Aircraft Design Certification GmbH Reichensteinstr.48 69151 Neckargemünd		Scratching- protection of seat bracket (DC-096)	Doc-Nr: ADxC-73-SB-033 Issue: A Date: 22.05.2023 ChangeNr.: ADxC-DC-73-096
Service Bulletin

Scratching-protection of seat bracket (DC-096)
SERVICE BULLETIN

<p>Scratching-protection of seat bracket (DC-096)</p> <p>Introduce means of protection against chafing of the solid rivets heads on the main center spar and of the spar web from the seat brackets</p>
--

Figure 3: Installed original seat bracket (red line) on rivet heads (orange).

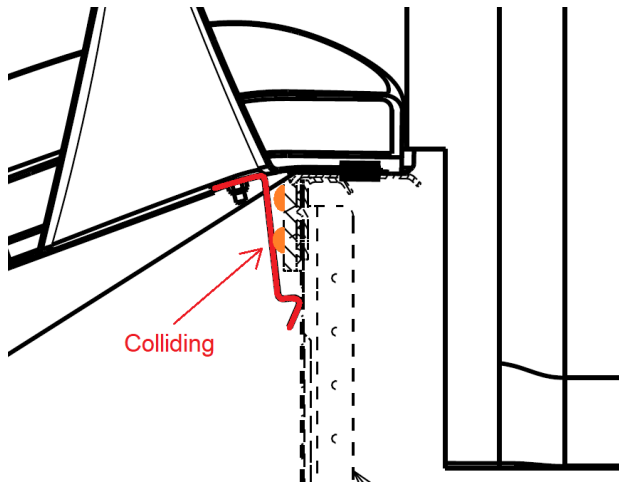
Eliminating the root cause of chafing of the solid rivets heads on the main center spar and of the spar web.

The unsafe condition is excessive wear of the solid rivets heads on the main center spar and of the spar web.

If criteria in Section 0 met, replace the seat bracket 25B210051N by seat bracket assembly 25B210052N.

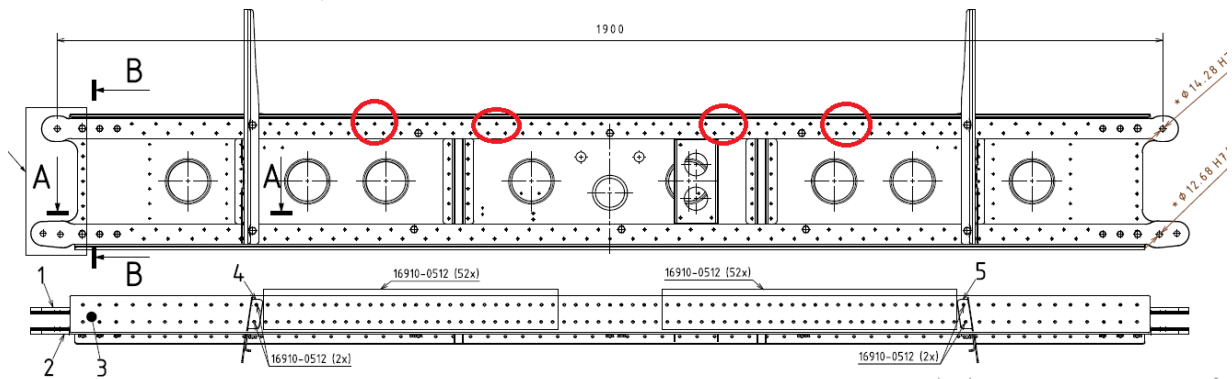
- 1) Replace the old seat brackets 25B210051N by new bracket assembly 25B210052N on the seat (25B210049N).
 - a) Replace self-locking nut (M5 DIN985 ZN) if needed.
- 2) Examine rivets and web of the main spar 53B230000N for excessive wear in the vicinity of the seat brackets, which were in contact with the seat bracket.

- a) Check wear of original rivets, the maximum allowed chafed diameter is 4 mm on the concerned rivet.

- b) If chafed diameter is larger:
 - i) replace original rivet by a CherryMax rivet CR3553-5-08.
 - ii) Check fastened rivets from the inside of the main spar, e.g. by means of mirror ore borescope.
 - c) Check concerned web areas for excessive wear. If it is not excessive, polish and paint them. If it is excessive, request repair order.
- 3) Make a log book entry and add note to aircraft CAW documentation that this Service bulletin has been incorporated.
